| Project:  | 76 Priory Road, NW6 3NT<br>Mr. & Mrs. W. Grigull | 76PR   |
| Proposed: | Site Plan                                        | P001   |
| Status:   | Planning                                         |        |
| Date:     | January 2008                                     | Rev: A |

| Proposed: | Section B                                        | P012   |

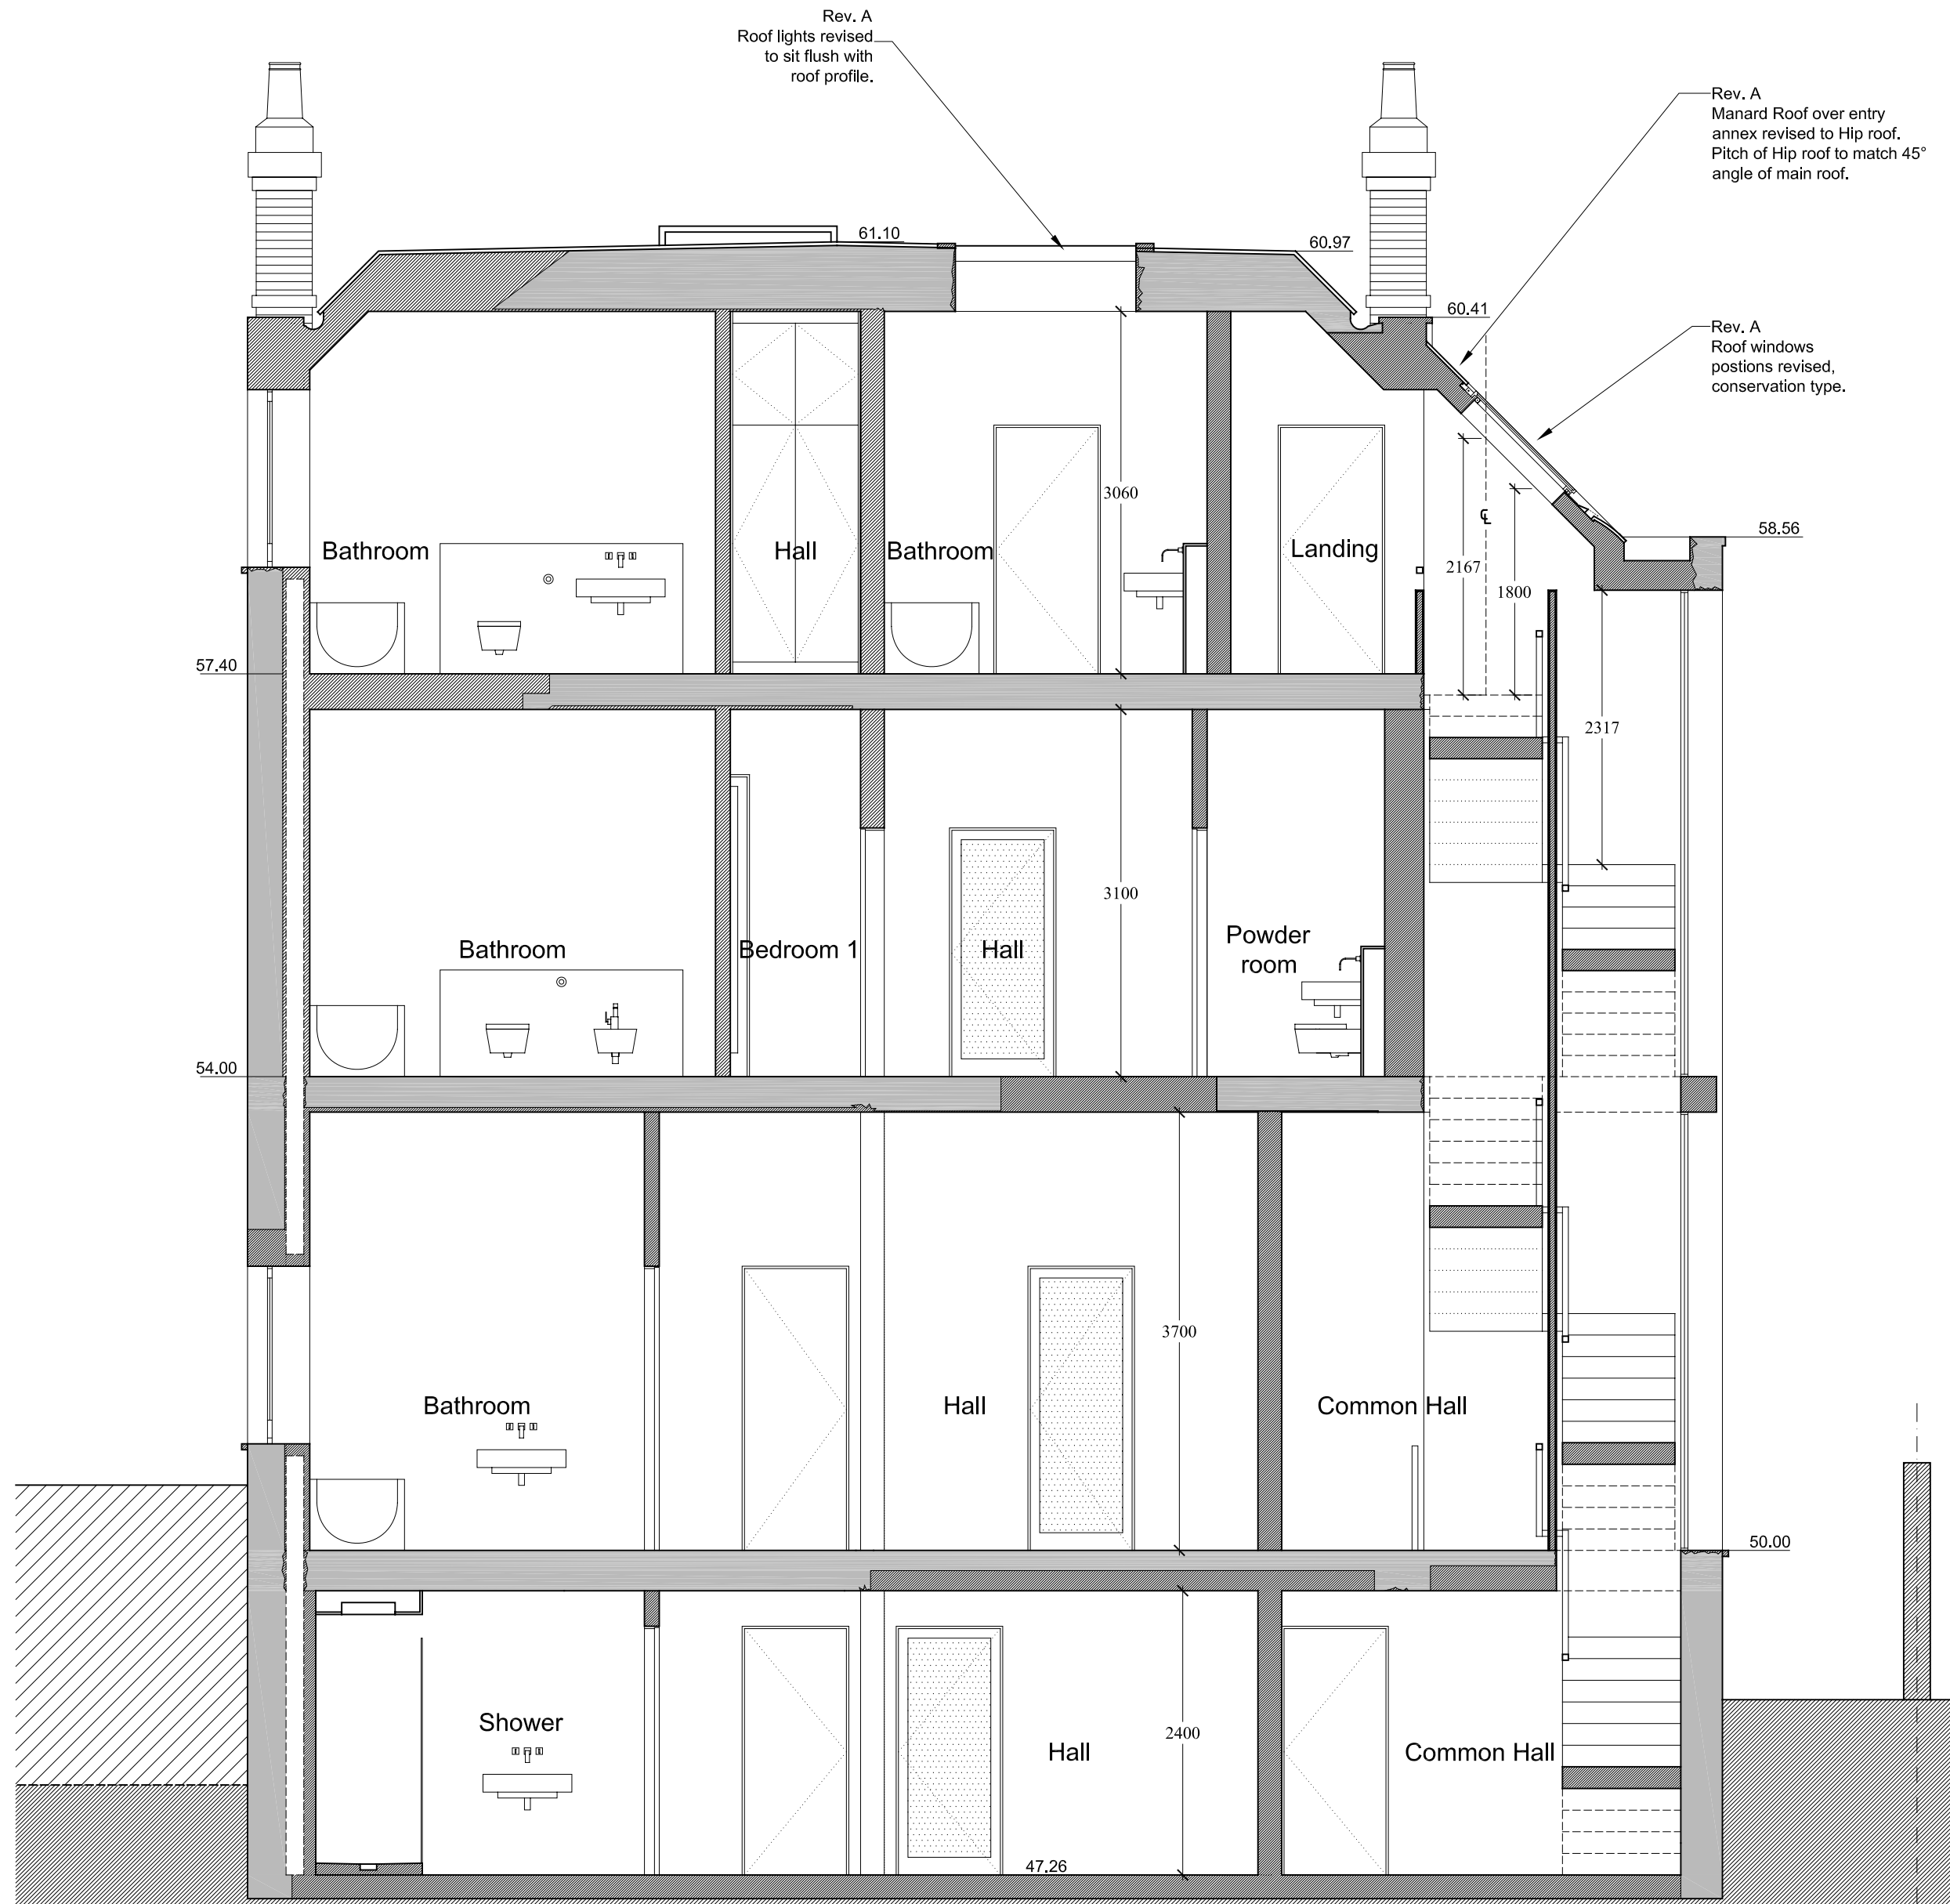
Revisions:  
Rev A: 05-03-2008  
^Mansard roof on side entry annex revised to Hip roof form.  
^Chimney note added.  
^Railings to front light well removed & horizontal grill added.  
^Roof lights to sit flush with roof profile.  
^Rear dormer windows revised to sit within existing position.

| Proposed: | Section CC & D                                   | P013   |

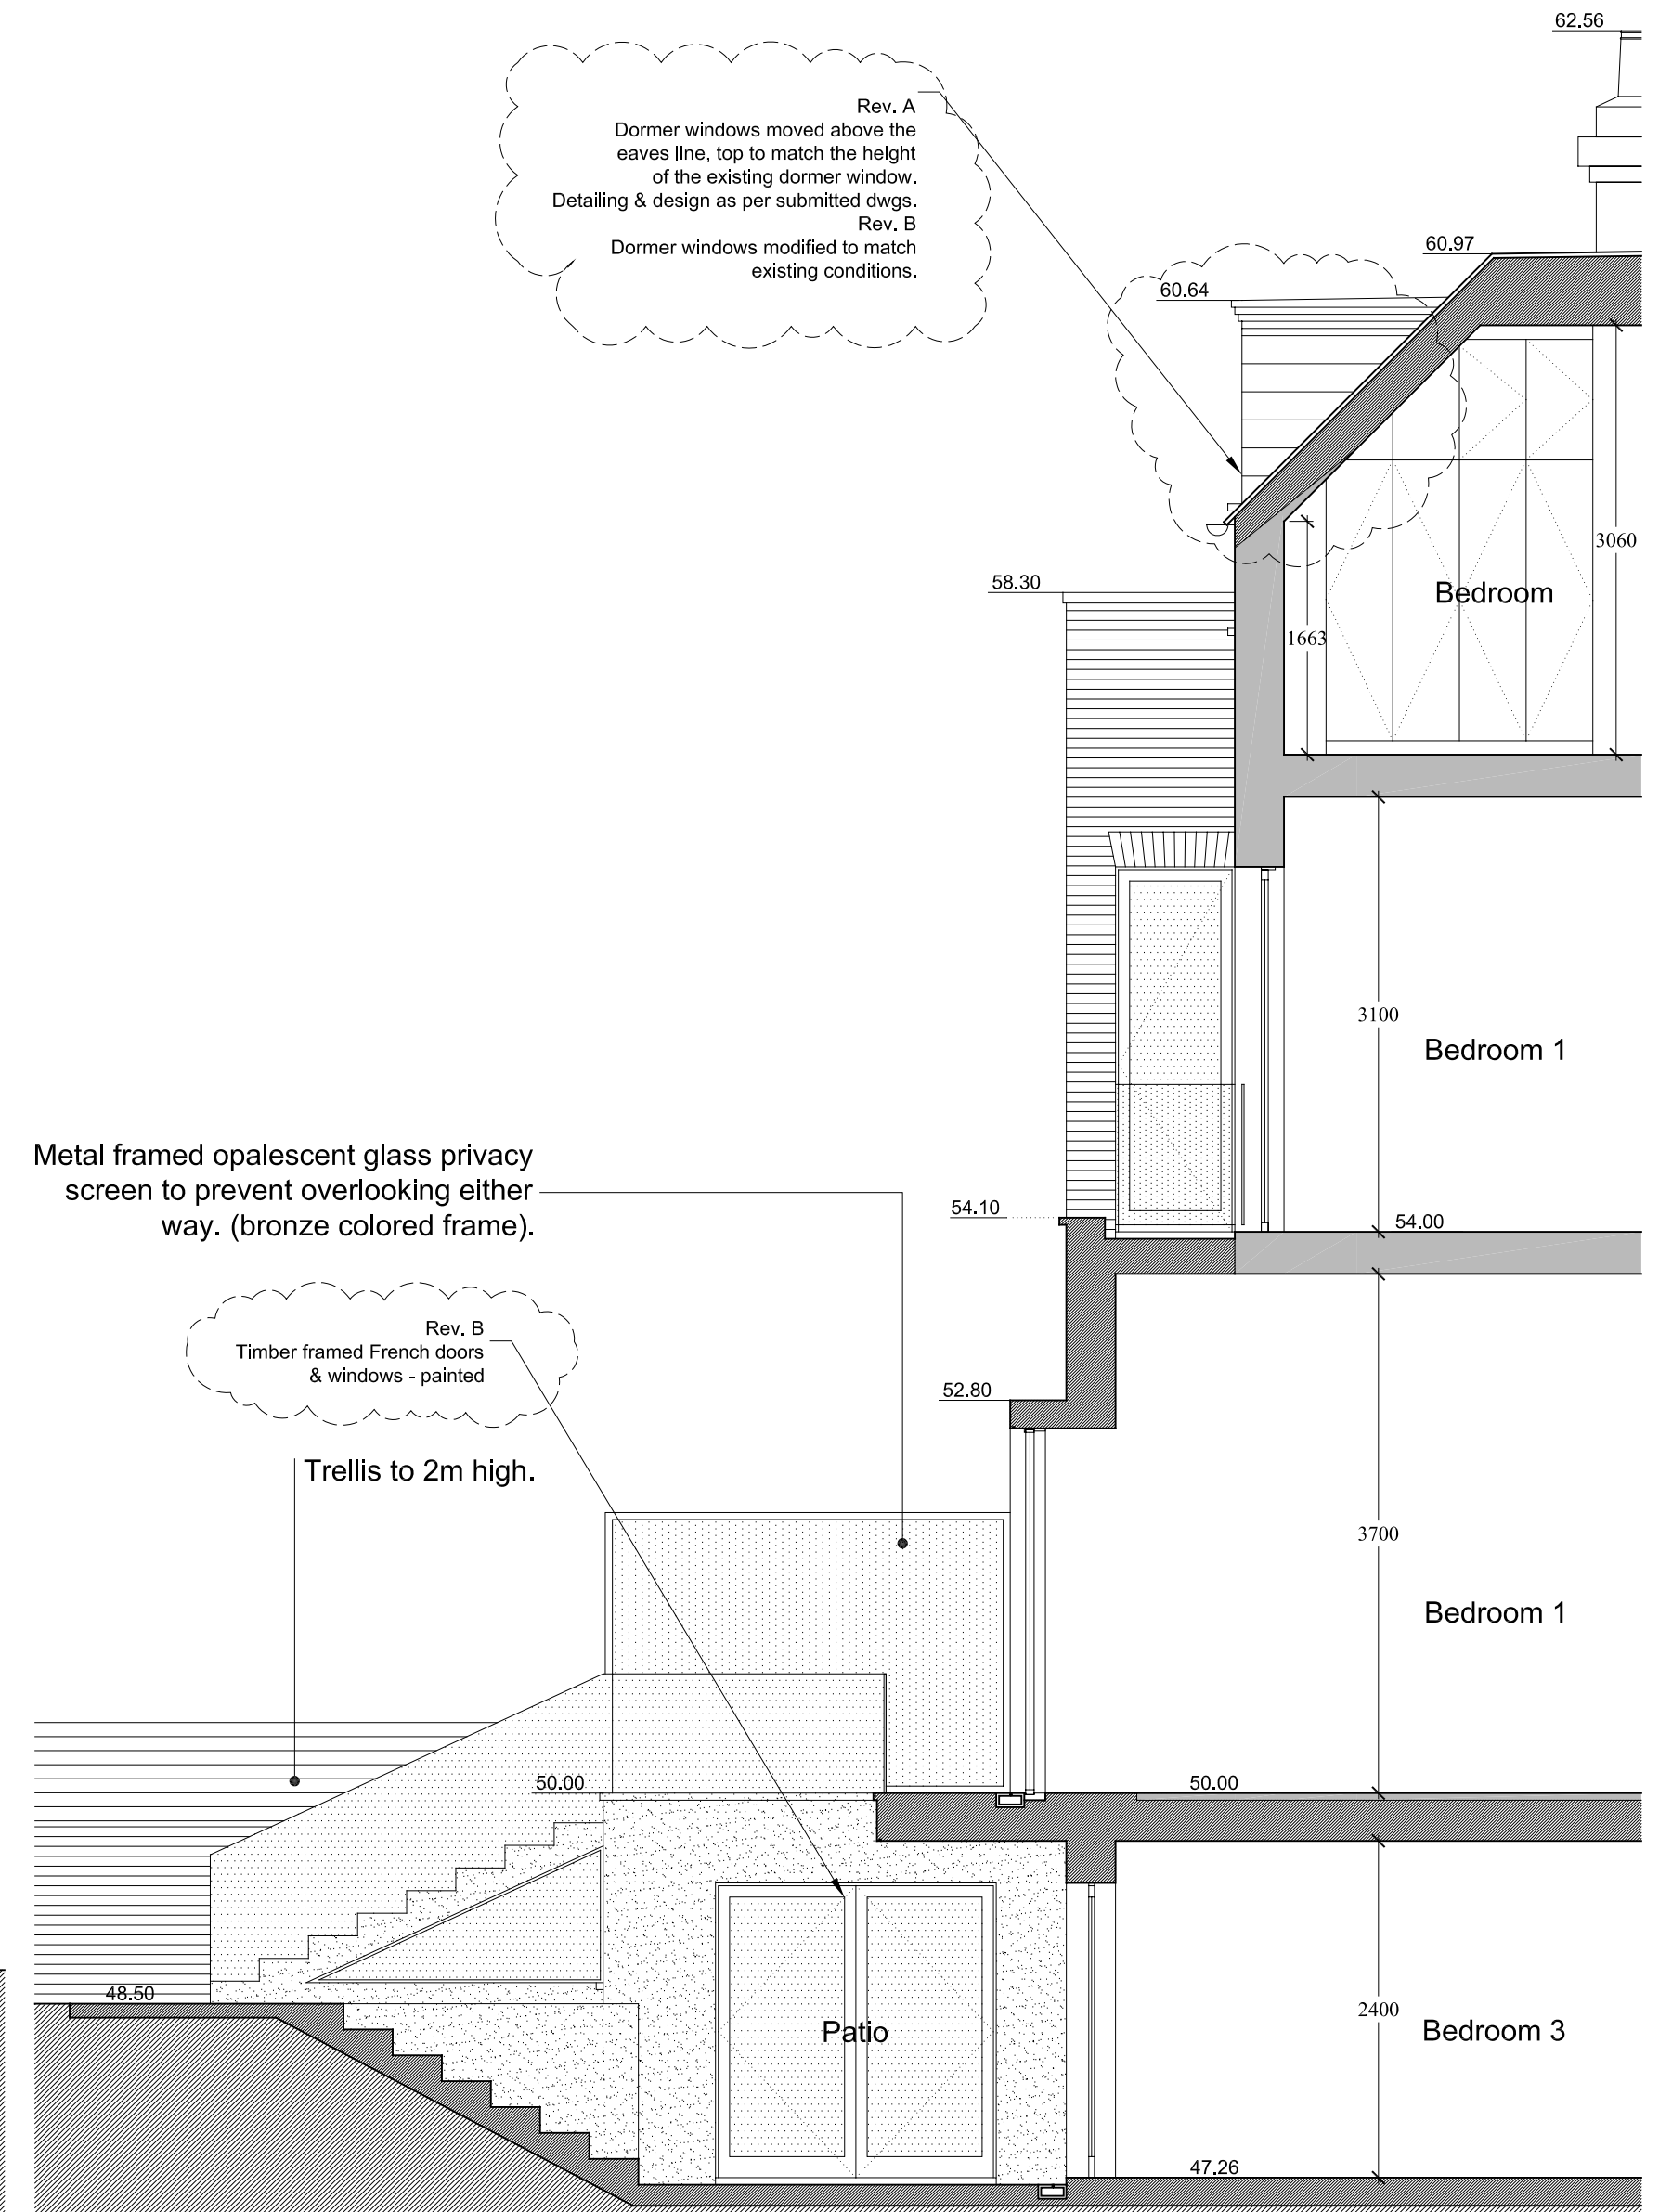
\*Mansard roof on side entry annex revised to Hip roof form.  
\*Chimney note added.  
\*Railings to front light well removed & horizontal grill added.  
\*Roof lights to sit flush with roof profile.  
\*Rear dormer windows revised to sit within existing position.

\*Rear Dormer windows revised to match existing conditions.  
\*Rear Dormer windows revised to Timber frames.  
\*Rear LGF & FF window notes revised.  
\*Detail Section EE added.
